Project	<b>IEEE 802.16 Broadband Wireless Access Working Group</b> < <a href="http://ieee802.org/16">http://ieee802.org/16</a> >	
Title	<b>Problems with Initial Ranging in OFDM PHY and a Solution</b>	
Date Submitted	<b>2005-01-13</b>	
Source(s)	David A Castelow, Gavin Meakes, Eyal Verbin  Airspan Communications, Cambridge House, Oxford Road, Uxbridge, UK	Voice: +44 1895 467281 Fax: +44 1895 467202 <a href="mailto:dcastelow@airspan.com">mailto:dcastelow@airspan.com</a>
	Joël Demarty, Ambroise Popper  SEQUANS Communications 101-103 bld Mc Donald, 75019 Paris, France	Voice: +33 1 44 89 48 07 <a href="mailto:joel@sequans.com">mailto:joel@sequans.com</a>
Re:	Supporting document for Comment to 802.16maint.	
Abstract	Changes required in order enabling good operation of 802.16 systems.	
Purpose	The document is intended for consideration within the comments resolution process.	
Notice	This document has been prepared to assist IEEE 802.16. It is offered as a basis for discussion and is not binding on the contributing individual(s) or organization(s). The material in this document is subject to change in form and content after further study. The contributor(s) reserve(s) the right to add, ame

Figure 61 – Initial Ranging – SS (part 2)

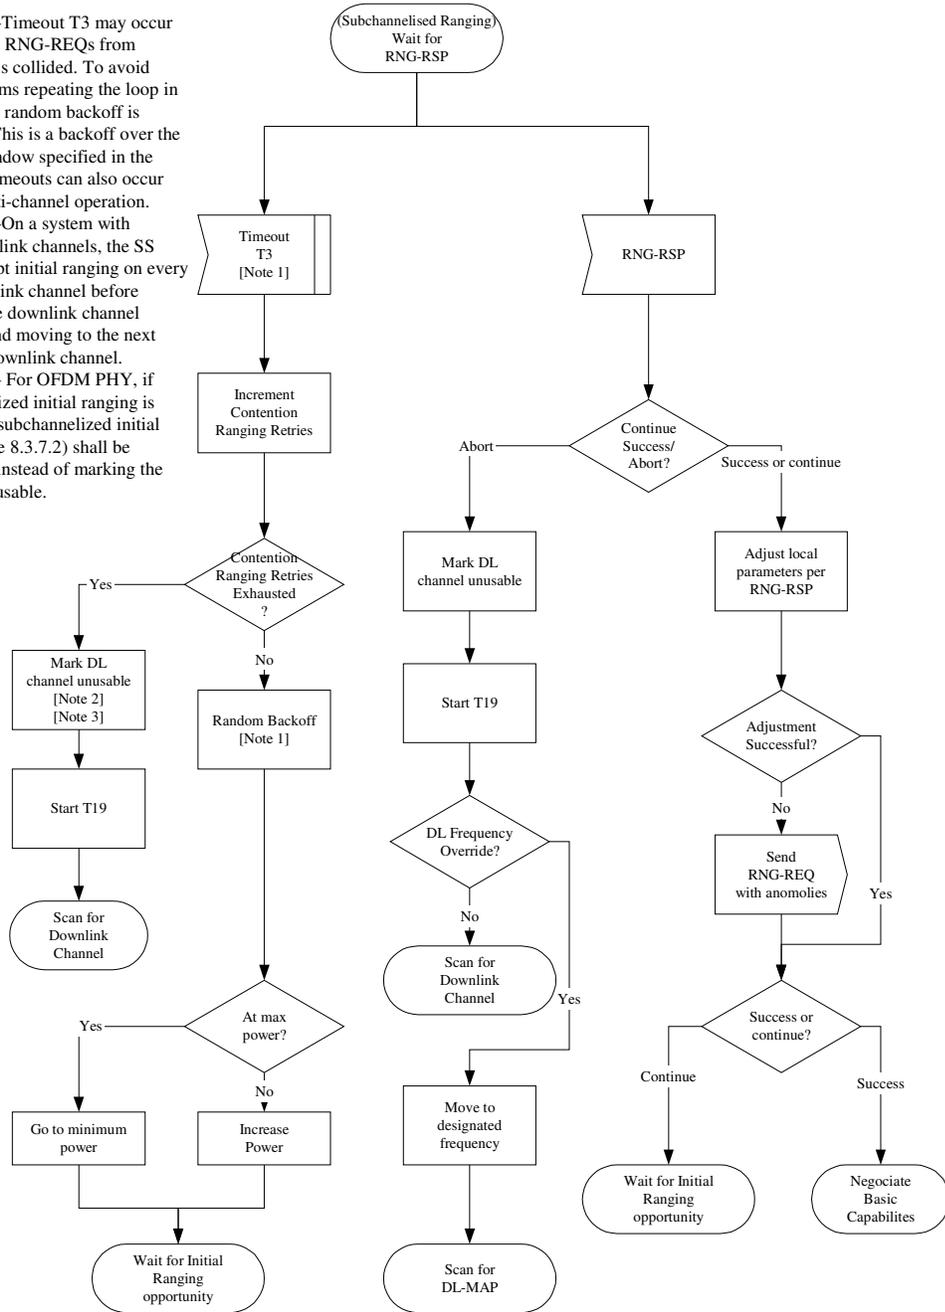
[Replace Figure 61 with the following figure:]

NOTE 1 —Timeout T3 may occur because the RNG-REQs from multiple SSSs collided. To avoid these modems repeating the loop in lock-step, a random backoff is required. This is a backoff over the ranging window specified in the UCD. T3 timeouts can also occur during multi-channel operation.  
 NOTE 2 —On a system with multiple uplink channels, the SS must attempt initial ranging on every suitable uplink channel before marking the downlink channel unusable and moving to the next available downlink channel.  
 NOTE 3 — For OFDM PHY, if subchannelized initial ranging is supported, subchannelized initial ranging (see 8.3.7.2) shall be performed instead of marking the channel unusable.

Figure 210a – Subchannelized Initial Ranging – SS (part 1)

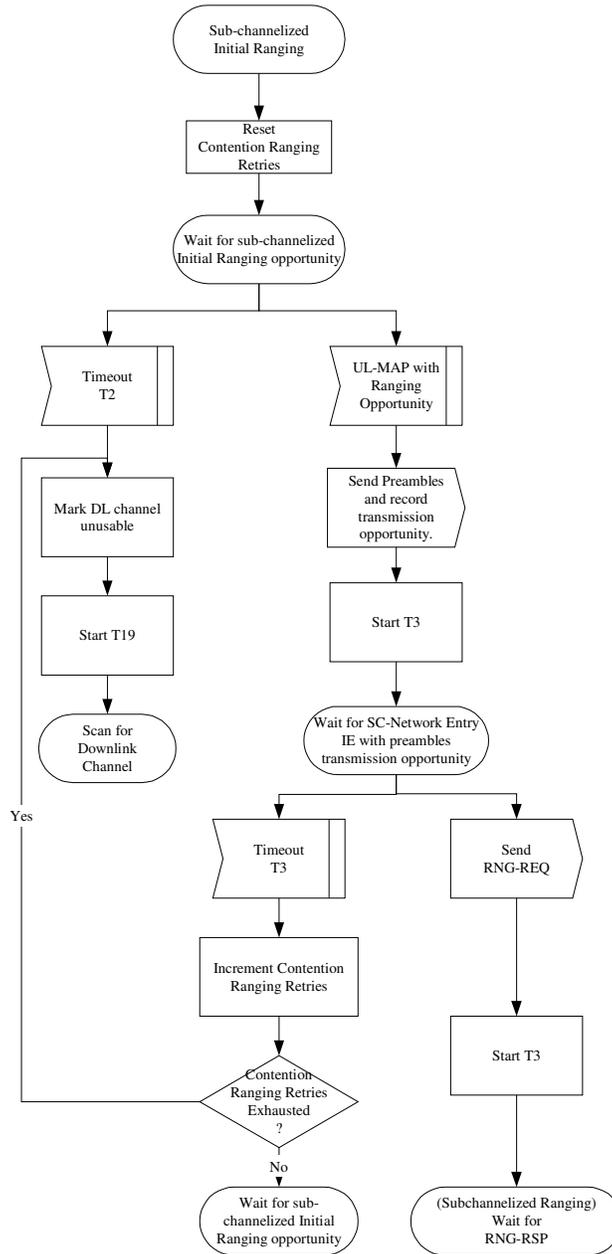
Alter section 8.3.7.2 as follows, and insert STL diagrams describing behaviour of SS (BS?) during sub-channelised initial ranging:  
 Add at page 479, line 38:  
 SSs which compute their PTX\_IR\_max to exceed their maximum power level and SSs which have attempted initial ranging with the maximum power level using RNG-REQ may, if they have exhausted their maximum number of retries during initial ranging and if the BS supports subchannelization, attempt initial ranging in an initial ranging slot using the following burst format, and as indicated in Figure 210a and Figure 210b:

NOTE 1 —Timeout T3 may occur because the RNG-REQs from multiple SSSs collided. To avoid these modems repeating the loop in lock-step, a random backoff is required. This is a backoff over the ranging window specified in the UCD. T3 timeouts can also occur during multi-channel operation.
